LATEST REVISION DATE 06-12 APPROVED BY BRIDGE ENGINEER <i>Thomas E. McQuill</i>	 STANDARD DESIGN - 40' ROADWAY, 3 SPAN BRIDGES CONTINUOUS CONCRETE SLAB BRIDGES NOVEMBER, 2006	
	SUPERSTRUCTURE DETAILS 90'-0' BRIDGE	J40-06-06

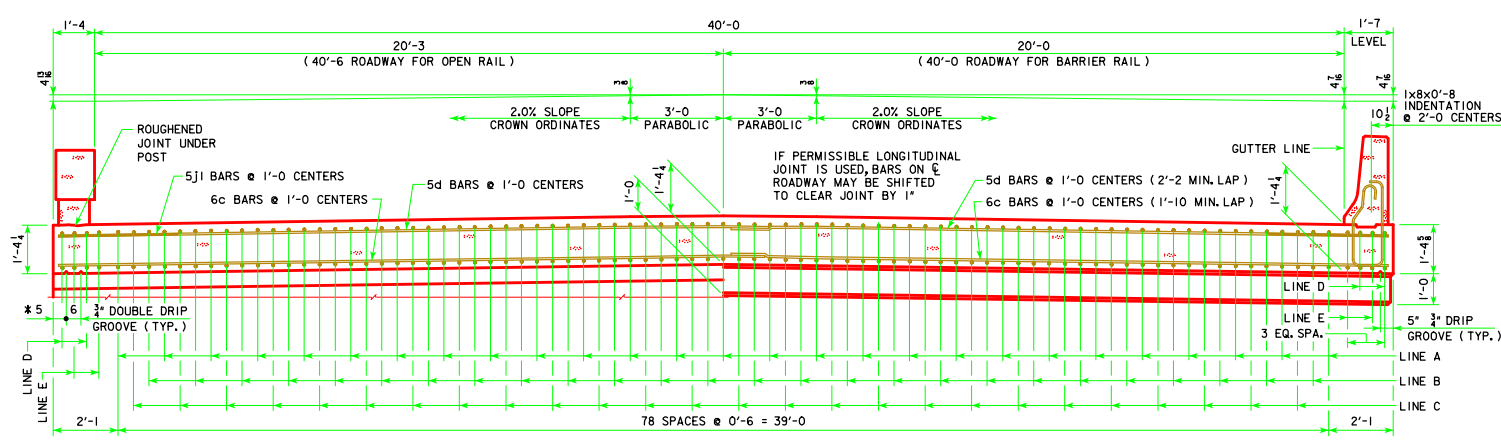
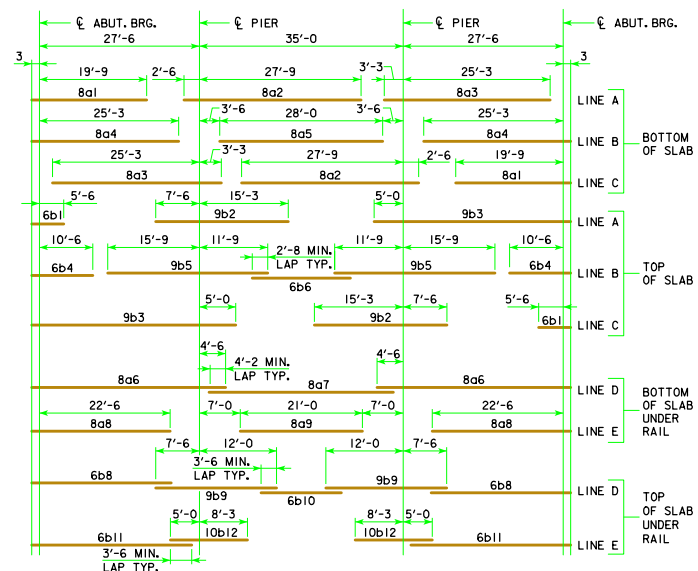
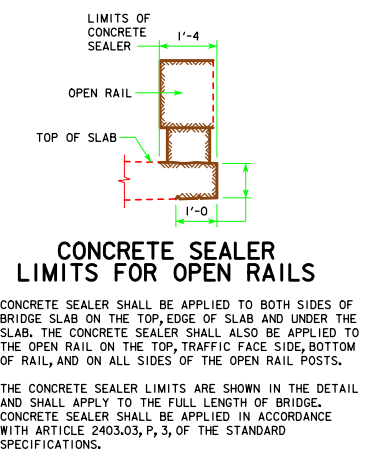
REVISED 06-12 - I.M. REQUIREMENT ADDED TO BAR CHAIR NOTE.
